JPB CAC

Item7a MTC Resolution No. 4537, Revised.

Major Project Advancement Policy: Stage Gate Evaluation and Recommendations for Transbay Joint Powers Authority - the Portal Project

2015 DTX draft SEIR

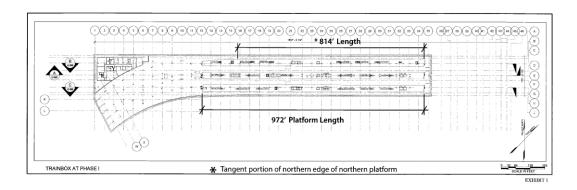
The last diagram in the letter shows that **the shortened platforms** cannot possibly accommodate a **1,350**-foot long Brightline West double-consist even though the box <u>as currently constructed</u> is **1,530** feet long.

I respectfully urge the commission to consider approving the advancement of the Portal (formerly known as the Downtown Extension or DTX for short) project to the next MAP Level with conditions and recommendations along the lines suggested in the 2015 SEIR which introduced a twin-bore alignment designed to resolve the above fatal flaw while enabling a future connection to the East Bay (LINK21) as mandated by SB916. https://hsr.ca.gov/wp-content/uploads/2022/05/Final EIRS FJ V4-09 Ch 24 IndividualComments.pdf (page 94) attached for your convenience.

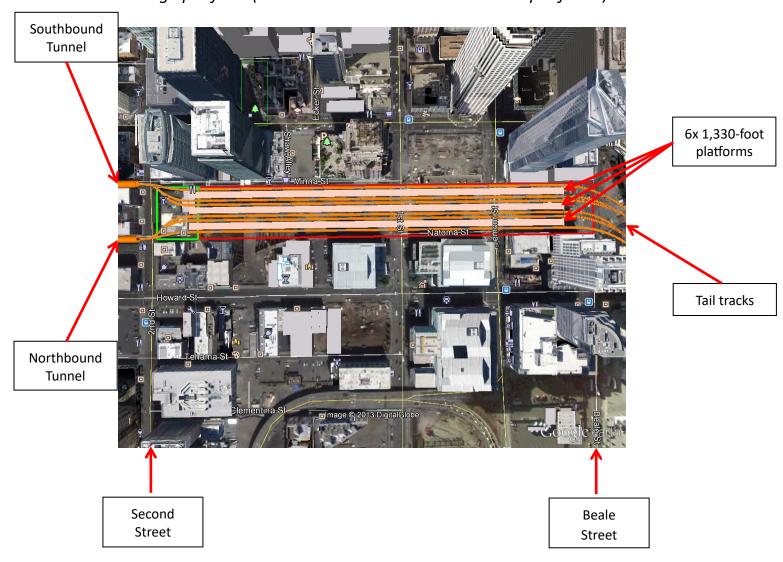
"The SEIR should consider an alternate DTX alignment which would enable platform lengthening by extending the train box one block west (towards 2nd Street) while simultaneously providing a viable connection to a Transbay tunnel. This alignment would also eliminate conflicts with the 201 Mission building and enable a 6th full-length through platform (total 3 eastbound and 3 westbound platforms)."

1) Train Box Extension

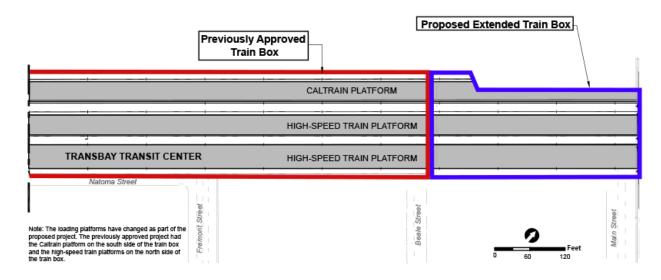
- The train box extension design violates SB916 (2003) codified in Streets & Highways Codes section 30914(22) (http://law.justia.com/codes/california/2011/shc/division-17/30910-30922/30914) by failing to provide any kind of engineering solution for a future East Bay extension

Recommendation #1

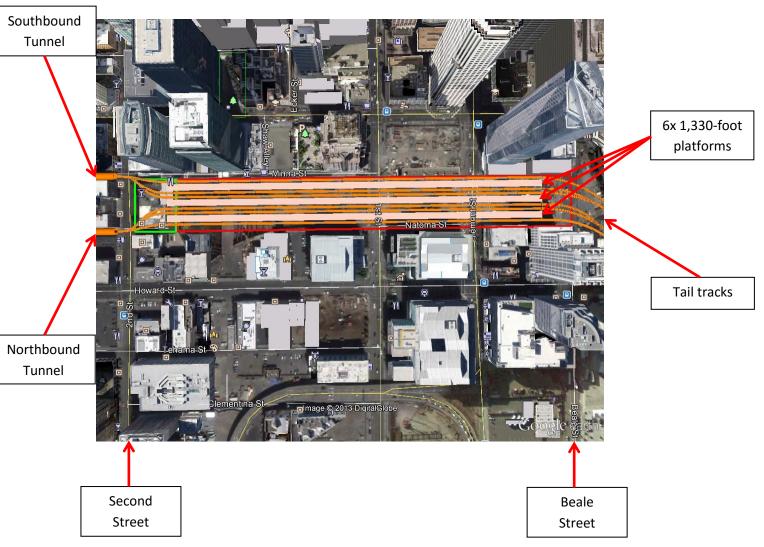
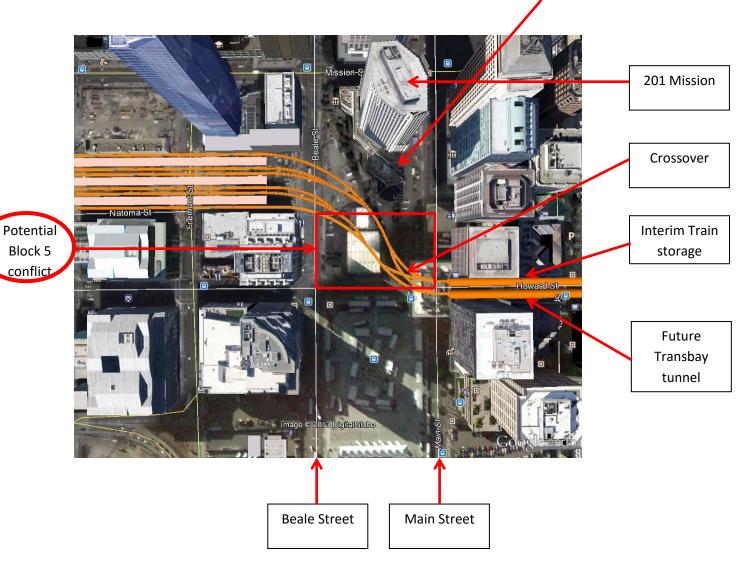
The SEIR should consider an alternate DTX alignment which would enable platform lengthening by extending the train box one block west (towards 2^{nd} Street) while simultaneously providing a viable connection to a Transbay tunnel. This alignment would also eliminate conflicts with the 201 Mission building and enable a 6^{th} full-length through platform (total 3 eastbound and 3 westbound platforms).

This alignment would eliminate the need to demolish the 201 Mission podium structure.

2) Widened throat structure

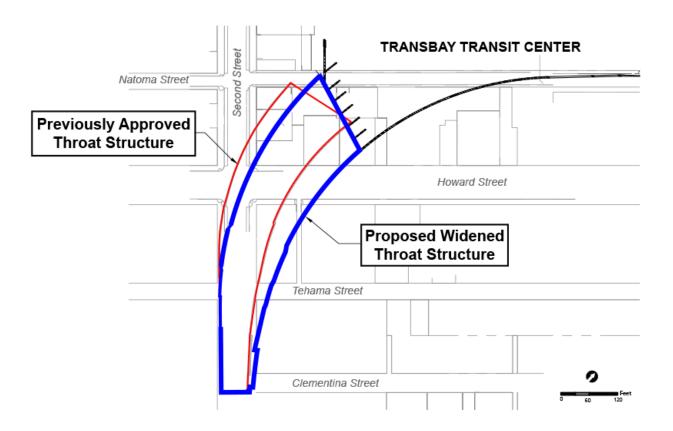
The SEIR proposes a widened approach to the Transbay Center train box via a massive cut & cover structure that will impact numerous properties as far south as Clementina Street. Construction costs are expected to run into the hundreds of millions and will result in massive circulation and noise impacts on the adjacent neighborhoods for many years.

Recommendation #2

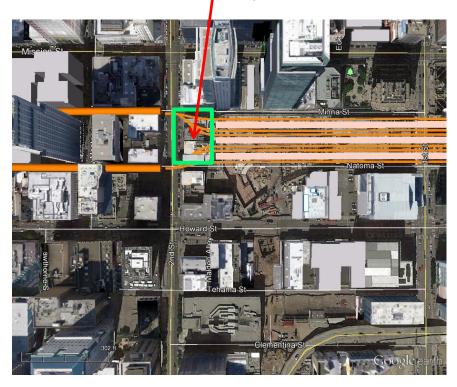
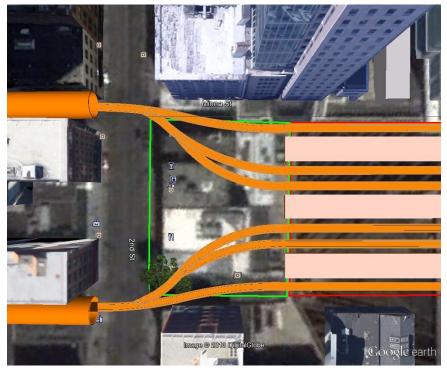
The SEIR should consider an alternate DTX alignment and construction technique that would limit impacts to a small number of buildings on 2nd Street between Minna and Natoma.

There would be no additional surface impacts in SOMA north of Townsend.

3) Tunnel design

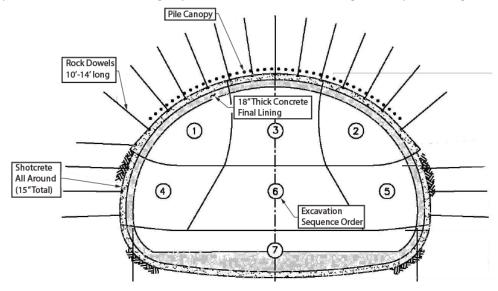
The current DTX design contemplates the construction of a 3-track sequentially excavated tunnel without any apparent plans for the evacuation of a train travelling on the middle track. This is of particular concern with High Speed trains which have a single door per carriage.

The SEIR should consider a twin-bore tunnel design with cross-passages for emergency evacuation (similar to the Central Subway) and a ventilation system designed to eliminate any requirement for vent/evacuation structures north of Townsend.

Recommendation #4

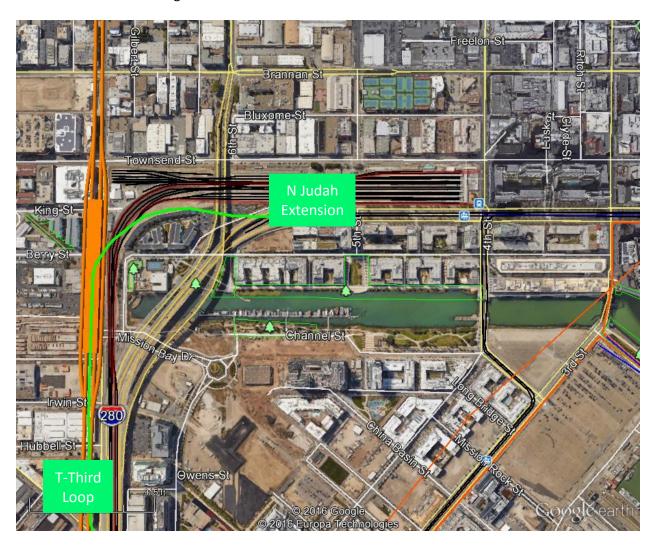
It is unclear how a relocated Caltrain station on Townsend could possibly accommodate the ridership demand from Mission Bay including UCSF, AT&T Park and the proposed Warriors Arena.

The SEIR should consider relocating the Townsend station to 7th Street and providing connectivity to the Central Subway via an extension of the N line connecting to the Mission Bay loop via 16th Street. This station should be designed to accommodate the Grand Boulevard at a later date.

5) 7th Street Tunnel Stub Box

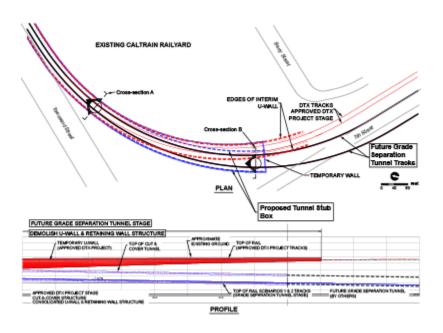
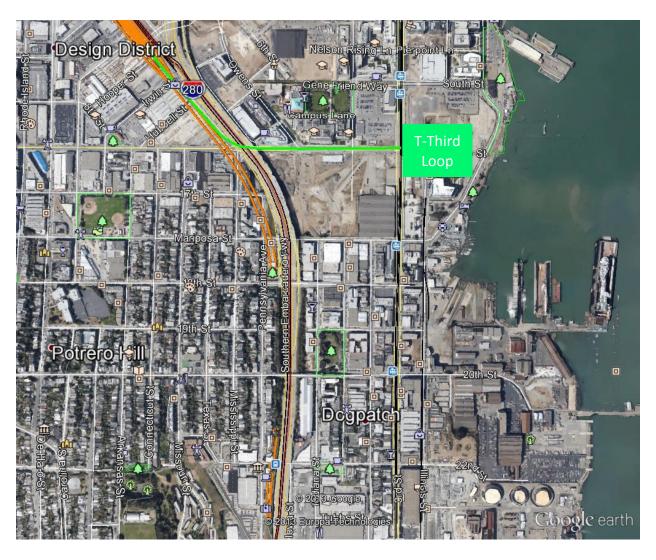
The SEIR proposes to terminate the DTX on 7^{th} Street with a "tunnel stub box" designed to accommodate a future 16^{th} Street grade separation.

The SEIR should consider a direct connection to the Planning Department's Pennsylvania Avenue RAB study alternative. This would achieve 16^{th} Street Grade separation as soon as Caltrain operations are relocated to the Transbay terminal and would save hundreds of millions by eliminating cut & cover structures @ 7^{th} & Townsend

6) Turnback Track impacts on 16th Street grade crossing

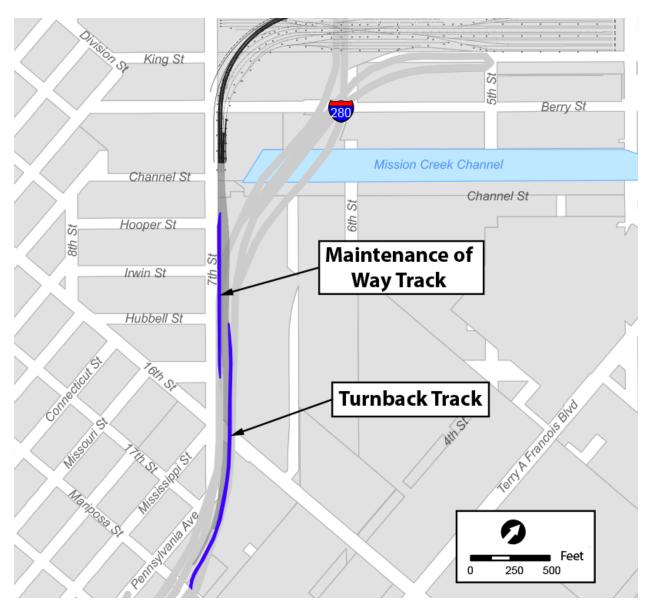
The SEIR proposes the addition of two additional tracks on 7th Street, including a turnback track across 16th Street, thereby increasing gate downtime for each train crossing by an additional 10 seconds (10 minutes per day).

Recommendation #6

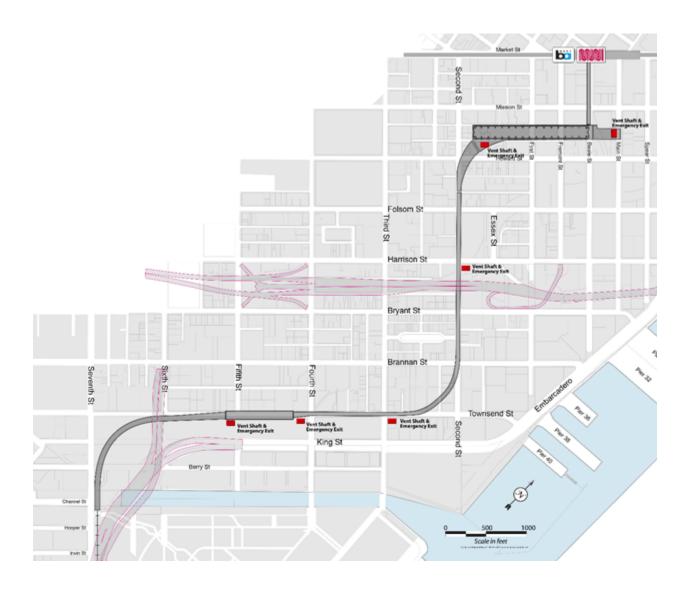
The SEIR should consider a direct connection to the planning department's Pennsylvania Avenue alternative (see recommendation #5 above) and turn trains around further south. The SEIR should also consider the abandoned tunnel #1 for storage.

Recommendation #7

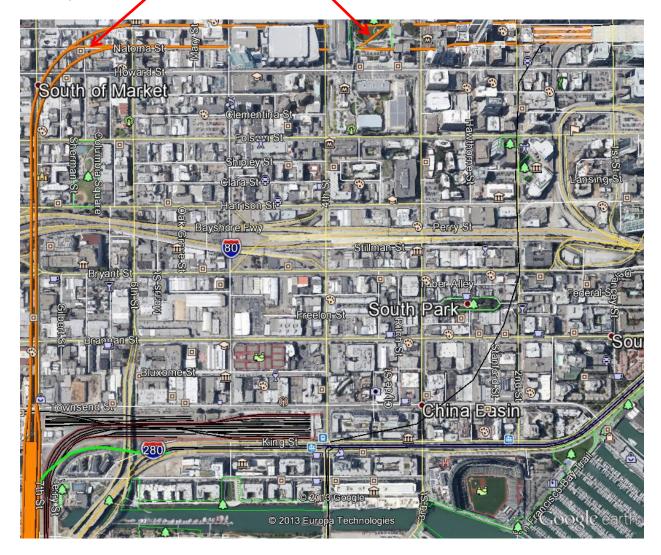
The current DTX alignment consists of 3 sharp curves each with a maximum speed of 25 MPH which extend the travel time between 7th Street and the Transbay Terminal by an additional 3 minutes.

The SEIR should consider an alternate alignment designed to enable an 80 MPH approach to the Transbay Transit Center.
